Re: Bayer MaterialScience LLC
125 New South Road – Hicksville, New York
USEPA ID#: NYD002920312
AOC 45 ICM Soil Removal Work Plan
Response to NYSDEC Comments
BBL Project #: 2302.32303 #5

On behalf of Bayer MaterialScience LLC (Bayer), this letter responds to New York State Department of Environmental Conservation (NYSDEC) comments on the Area of Concern (AOC) 45 Interim Corrective Measure (ICM) Soil Removal Work Plan (“the Work Plan”) for the above-referenced site. The Work Plan is presented in a letter from Blasland, Bouck & Lee, Inc. (BBL) to the NYSDEC dated January 5, 2006. The NYSDEC comments are provided in your e-mail correspondence dated February 23, 2006. For ease of presentation, each NYSDEC comment is presented below, followed by Bayer’s response.

FIGURE
5

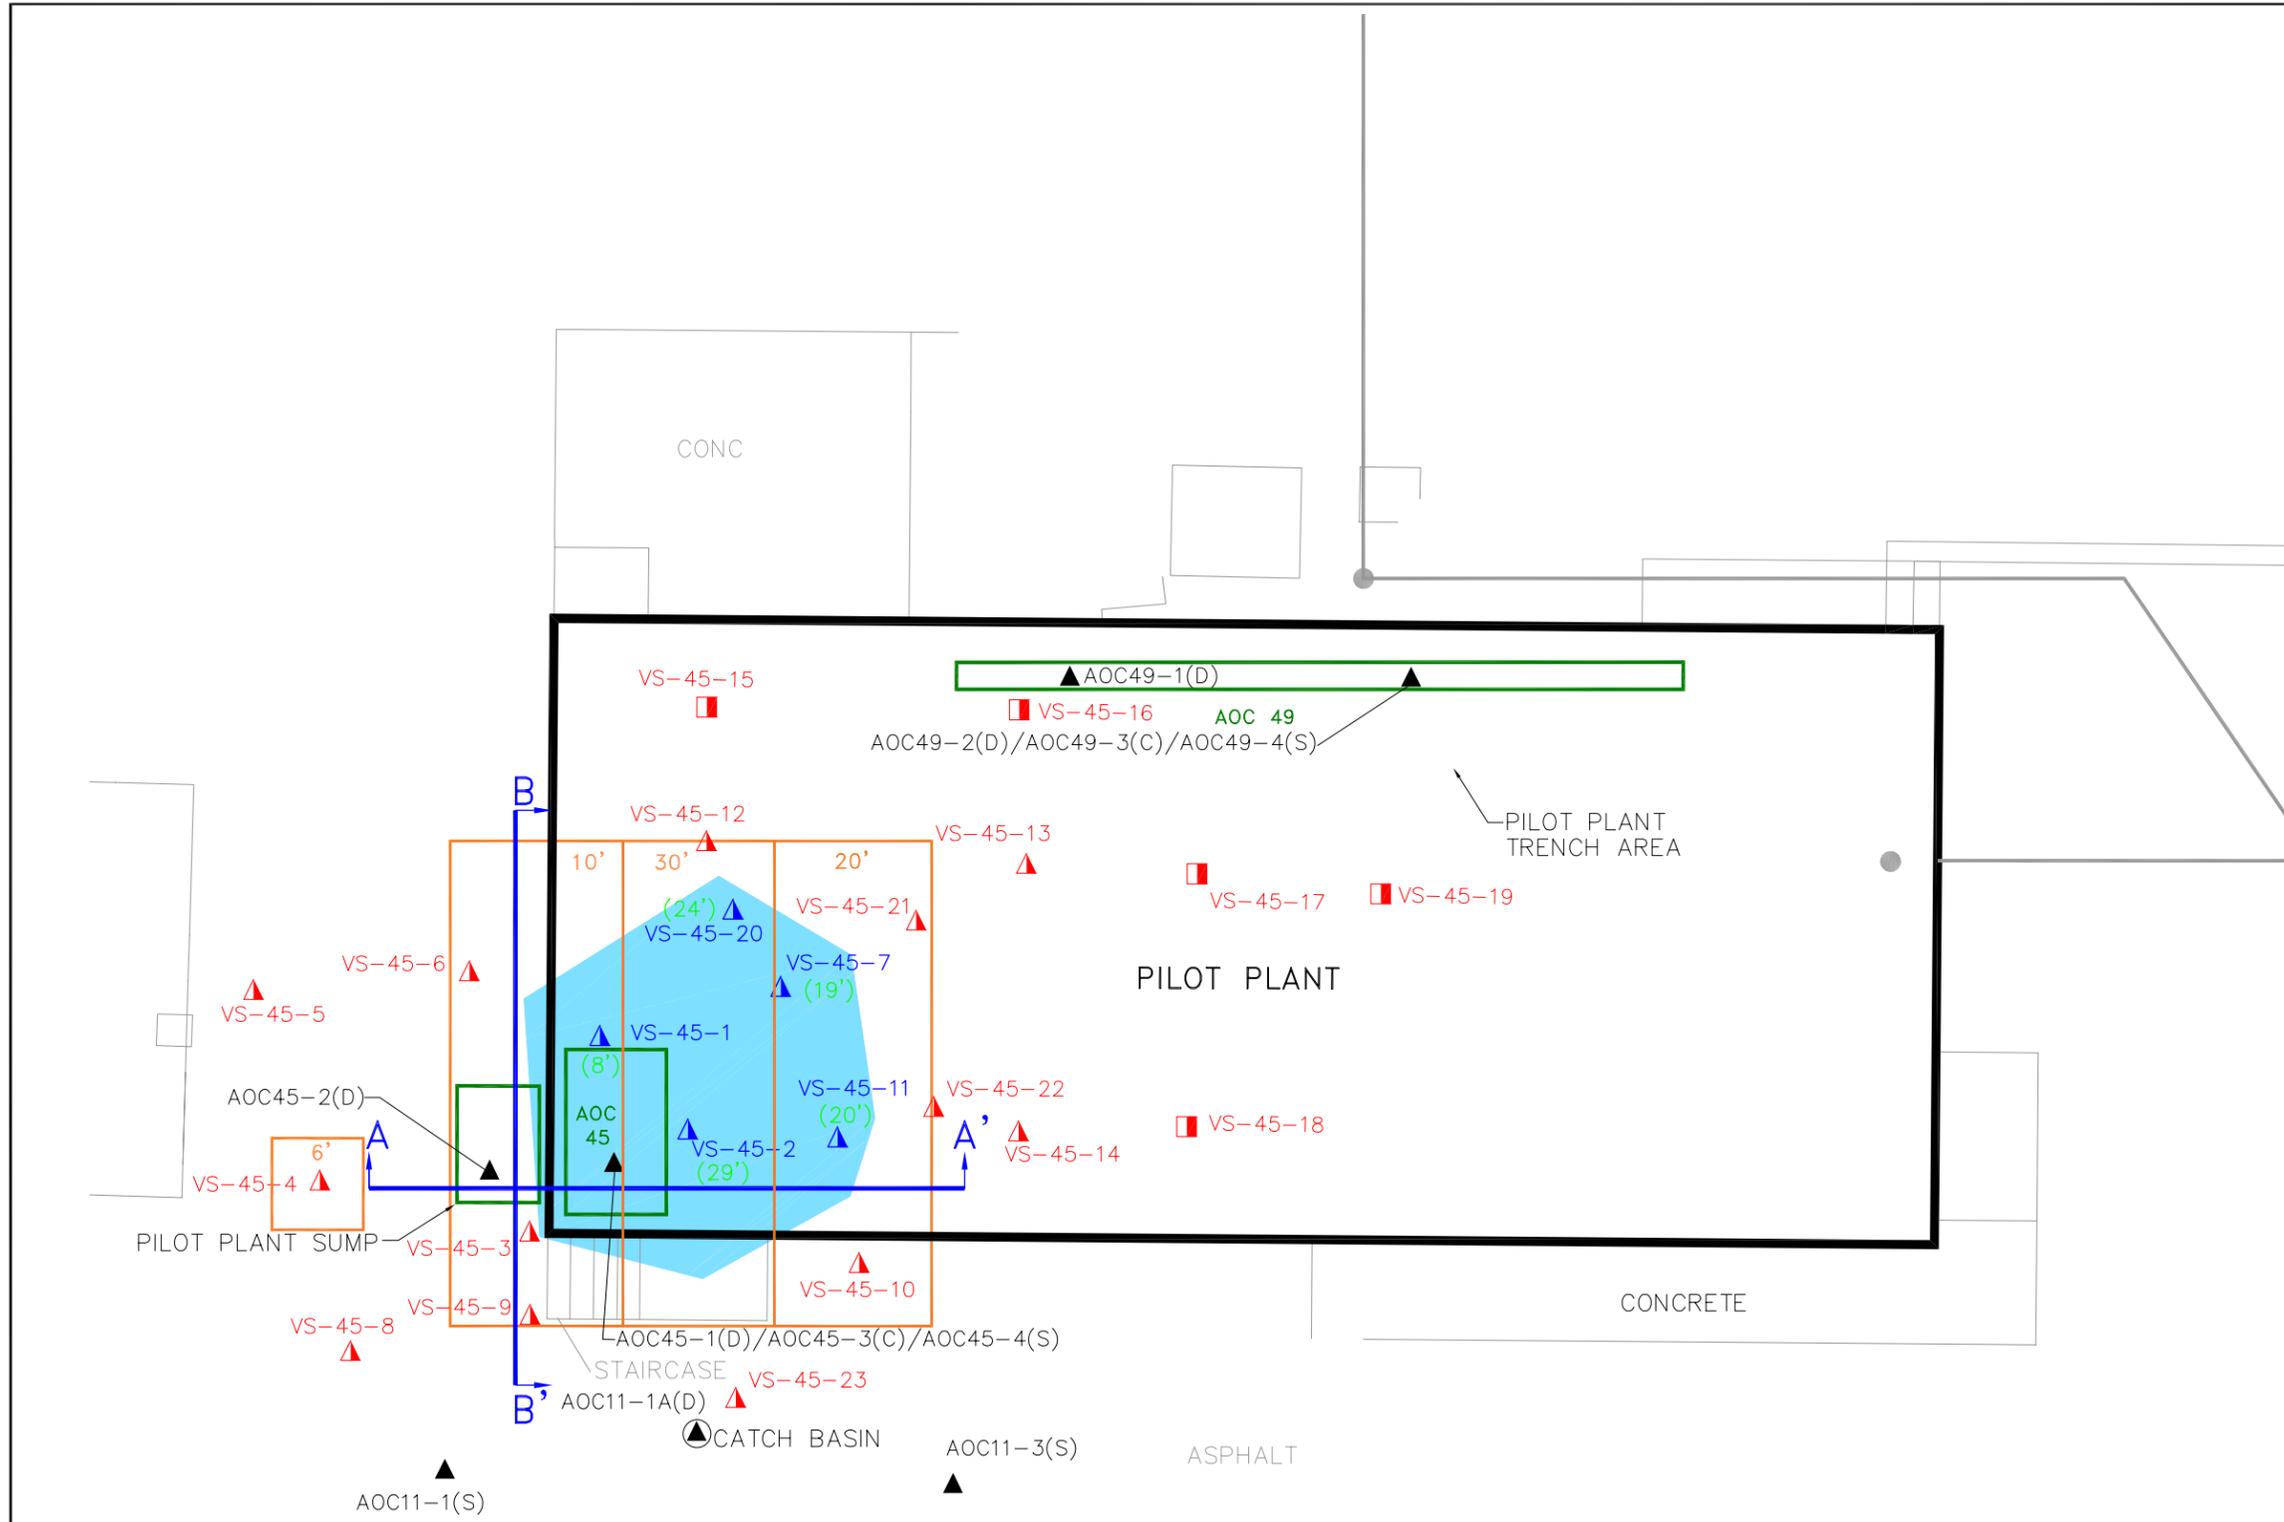
The work plan states that post-excavation verification soil sampling will not be performed, based on extensive pre-excavation delineation/verification soil sampling data already available. DEC disagrees with this proposal, as end point sampling must be performed to verify that PCB contaminated soils >50 ppm have been removed at the excavation limits.

As an alternative to the post-excavation sampling requested by the NYSDEC, Bayer proposes to expand the previously-proposed excavation limits outward in all directions to coincide with the first line of pre-excavation verification soil sampling locations where existing data already shows that PCB concentrations are less than the 50 ppm ICM soil cleanup objective. Note that the excavation limits shown on Figure 5 of the Work Plan were based on “mid-point” distances between those sampling locations exhibiting PCBs at concentrations above 50 ppm and the nearest sampling locations exhibiting PCBs at concentrations below 50 ppm. The proposed new excavation limits (which are now based on “end-point” data) are shown on the attached, revised version of Figure 5 from the Work Plan. As shown on the revised figure, Bayer is also now proposing to excavate soils from a 25-square foot area directly west of AOC 45. This proposed “second” excavation area will be centered around existing sampling location VS-45-4 where PCBs were identified in soils at the 4.5- to 5.0-foot depth interval at a concentration of 45 ppm. Soils from this “second” area will be removed to a depth of 6.5 feet below ground surface (bgs). Based on the existing analytical data, the soils to remain at the bottom of the excavation contain PCBs at an estimated concentration of 11.5 ppm. As a conservative measure, the impacted soils from this second excavation area will be transported for offsite disposal as a Toxic Substances Control Act- (TSCA-) regulated PCB waste and New York State hazardous waste (Waste Code B007).

As shown on Figure 5, a total of 14 boreholes were drilled and sampled within the 26-foot by 27-foot area that defines where PCB concentrations are greater than 50 ppm. This is equivalent to one borehole for every 50 square feet (i.e., approximately a 7-foot by 7-foot area). Furthermore, the PCB concentrations identified in the soils along the proposed new excavation limits are not only well-below the 50 ppm ICM cleanup objective, but they are also well-below the 10 ppm subsurface soil cleanup objective presented in the NYSDEC Technical Administrative Guidance Memorandum titled "Determination of Soil Cleanup Objectives and Cleanup Levels," HWR-94-4046, dated January 24, 1994 (TAGM 4046). Similarly, the PCB concentrations identified in soils at each of the next closest sampling locations continuing away from the excavation are also well-below the 10 ppm TAGM 4046 subsurface soil guidance value. The notable concentration differences between the inside and outside of the proposed excavation (high concentrations inside vs. consistently low concentrations everywhere outside) and the high density of delineation further support that post-excavation verification sampling is not needed.

10 ppm [such as below sampling location VS-45-1 (8.8-9.8')], would be placed in separate stockpiles from the remaining soils removed outside the excavation boundaries shown on Figure 5. These soils that may be excavated for sloping purposes and are known to contain, or could potentially contain, PCBs at concentrations exceeding 10 ppm include: (1) soils excavated below a depth of 10 feet within the western one-third of the targeted "larger" excavation area; (2) soils excavated below a depth of 20 feet within the eastern one-third of the targeted "larger" excavation area; and (3) soils excavated below a depth of 7.5 feet within the targeted "smaller" excavation area. These soils would be transported for proper offsite disposal.
